Model: Bellini Finisher		Date: 31-May-00	No.: MB302001
Modified Article: Timing Pulley - 28Z		Prepared by: H.K.	
From: Technical Services Dept., GTS Division			
Reason for Modification:	<input type="checkbox"/> Parts catalog correction	<input type="checkbox"/> Vendor change	<input type="checkbox"/> To meet standards ( )
	<input type="checkbox"/> To facilitate assembly	<input type="checkbox"/> To improve reliability	
	<input type="checkbox"/> Part standardization	<input checked="" type="checkbox"/> Other

Model: Bellini Finisher		Date: 06-Jun-00	No.: MB302002
Modified Article: Guide Mylar		Prepared by: H.K.	
From: Technical Service Dept., GTS Division			
Reason for Modification:	<input checked="" type="checkbox"/> Parts catalog correction	<input type="checkbox"/> Vendor change	<input type="checkbox"/> To meet standards ( )
	<input type="checkbox"/> To facilitate assembly	<input type="checkbox"/> To improve reliability	
	<input type="checkbox"/> Part standardization	<input type="checkbox"/> Other

Model: Bellini Finisher		Date: 06-Jul-00	No.: MB302003
Modified Article: Positioning Fences		Prepared by: H.K.	
From: Technical Services Dept., GTS Division			
Reason for Modification:	<inp

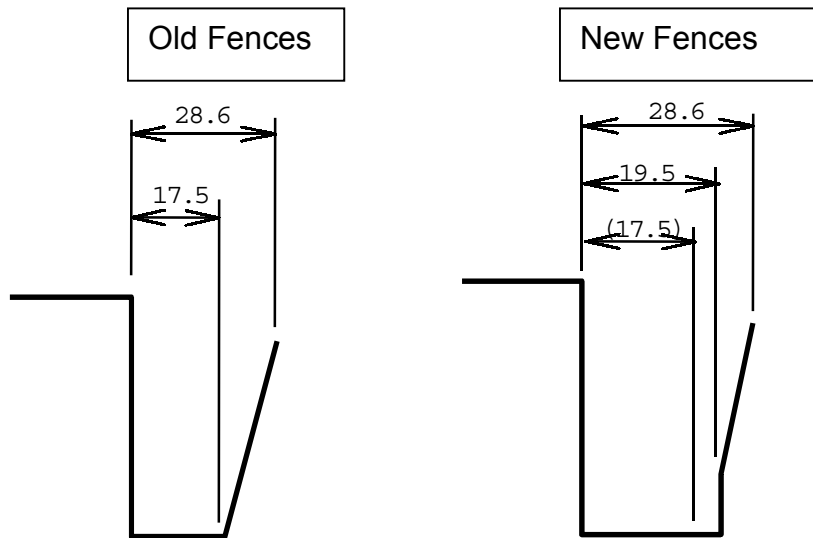
To improve stacking in the jogger unit, the production machines have been modified as follows:

- The widths of the positioning fences (Front, Middle, and Rear) have been modified as follows:

Note 1: When replacing either of the old fences in the field, install all three new parts as a set.

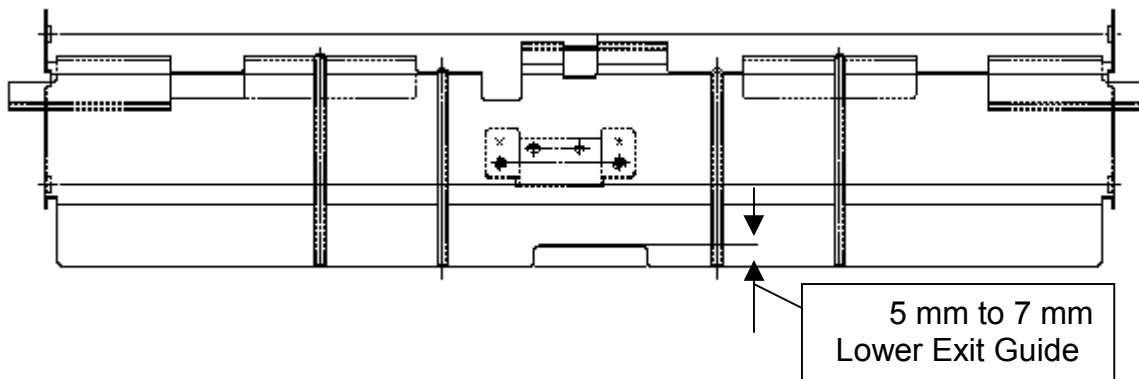
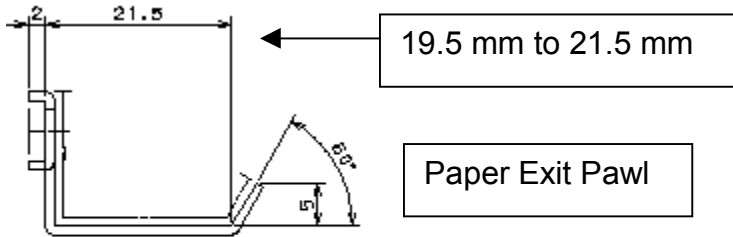
2. In addition to the widened three positioning fences, the shapes of the paper exit pawl and lower exit guide have been changed to improve transporting stapled copies.

Note 2: When replacing either of the old parts in the field, install both new parts as a set.

### Right Guide – Vertical Transport

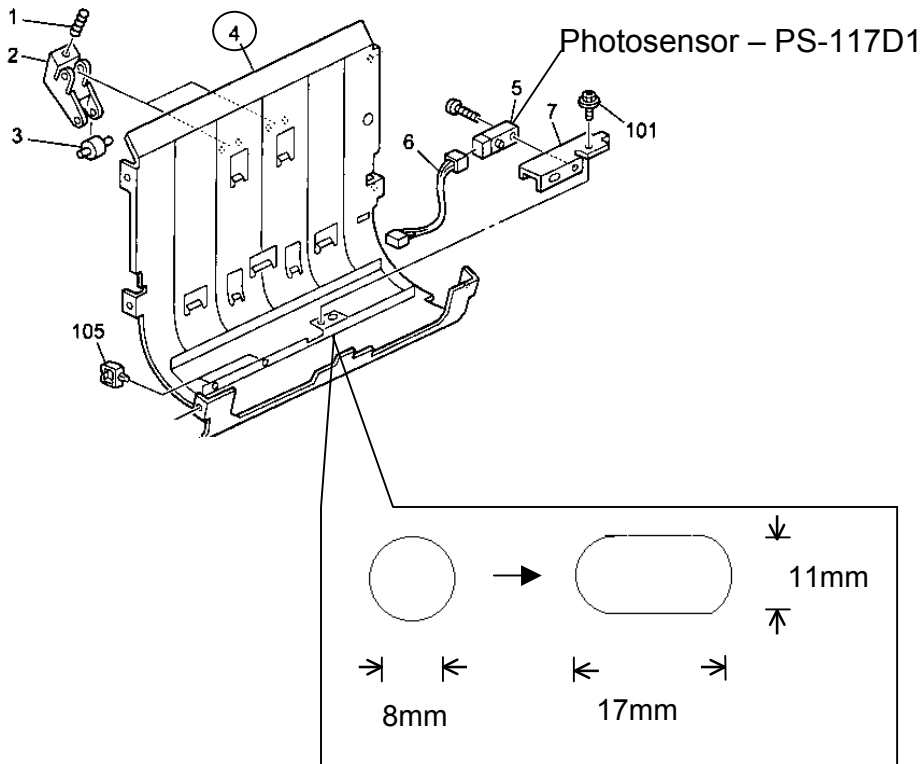
The size and shape of the photosensor window on the vertical transport right guide has been changed from 8 mm round to 11x17 mm square. This is to prevent the sensor from malfunctioning because of punch waste.

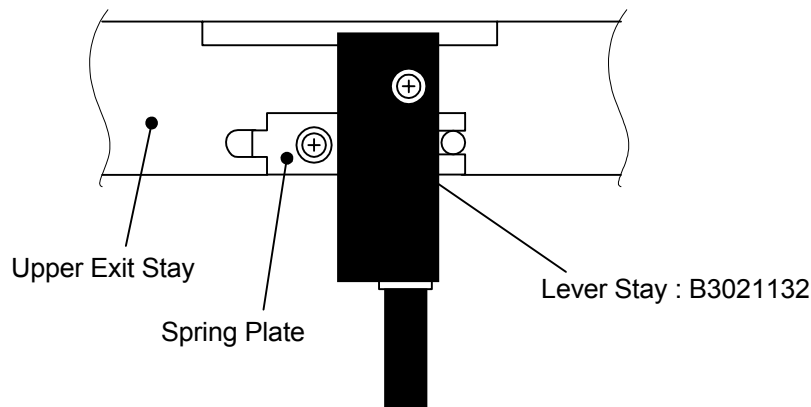
To improve the reliability of the spring plate and prevent any deformation, a lever stay has been added to the upper exit stay as shown below.

1: These parts should be replaced at the same time.
